REVISED LANTERN ROOM FLASHING 2-9-22

PT. PINDOS LIGHTHOUSE

Title:
LANTERN WALL SECTION FLASHING

Project:
POINT PINOS LIGHTHOUSE

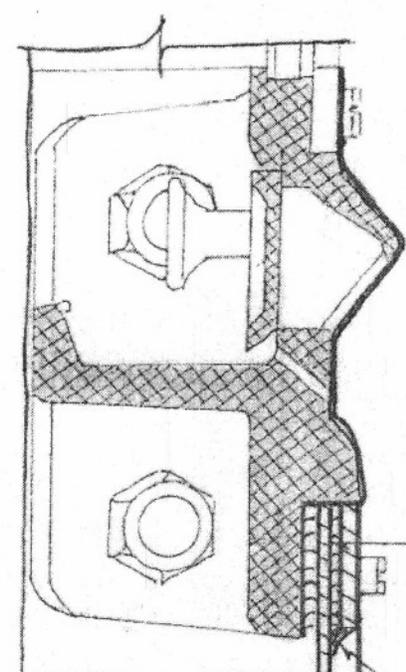
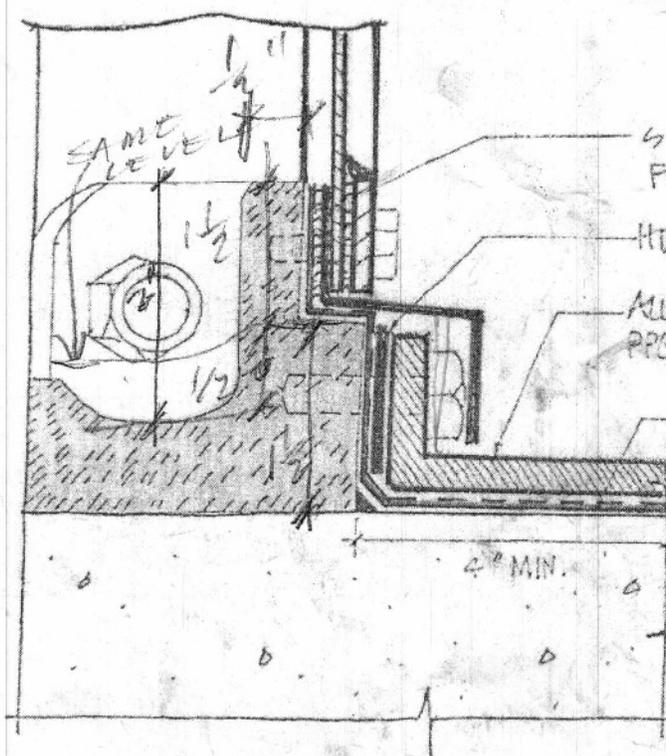
STEEL PANELS - PRIME WITH PPG AMERLOCK 2, PAINT WITH PPG PSX 700 OR 805. SET PANELS IN FULL BED OF SEALANT (TRENCO SPECTREM 2) AND DETAIL ALL JOINTS WITH SEALANT, TYP.

SEALANT JOINT - TRENCO SPECTREM 2, TYP.

S.S. FLASHING - MIN. 24GA WET SET IN FULL BED OF SEALANT

HDPE OR S.S. SPACER

ALUMINUM DIAMOND PLATE DECK - PRIME WITH PPG AMERLOCK 2, PAINT WITH PPG PSX 700 OR 805

CONCRETE LANTERN WALL FRAME - FABRIC REINFORCED CIM 1000 TYP. OVER SEALANT CNT. (CIM 1000TG)

MODIFIED DECK FLASHING PROPOSAL

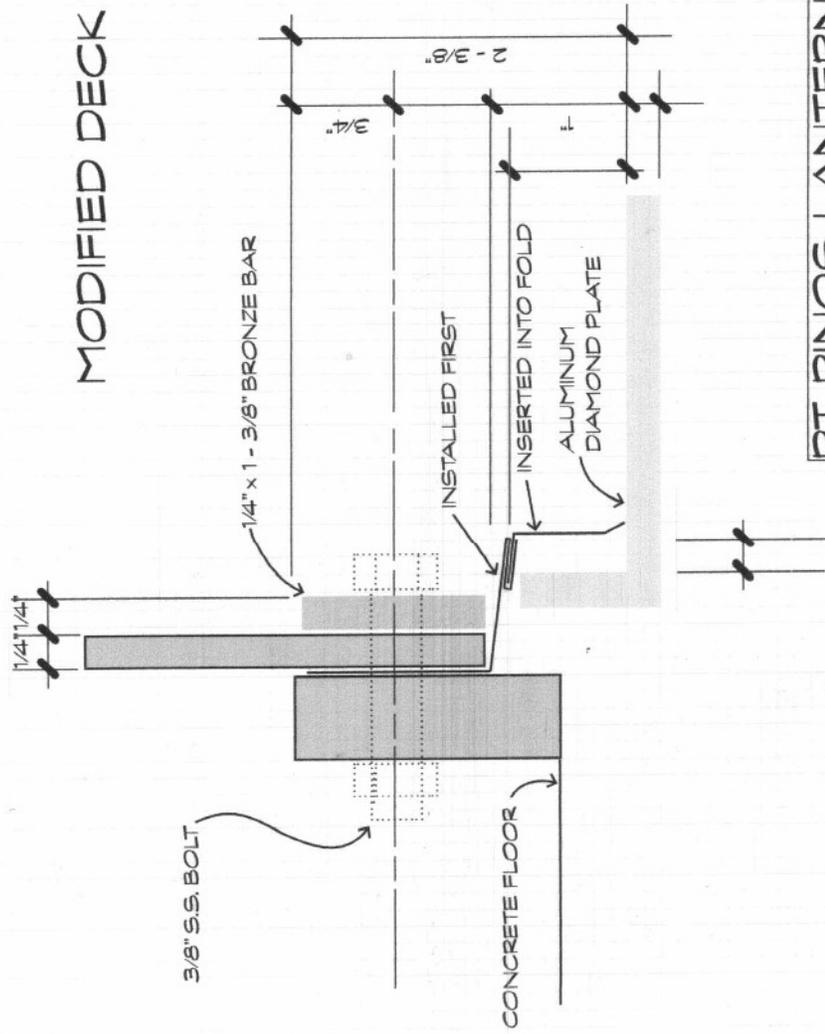
PT. PINOS LANTERN ROOM BASE

SCALE: APPROX. FULL SCALE, SPACES EXAGGERATED FOR CLARITY
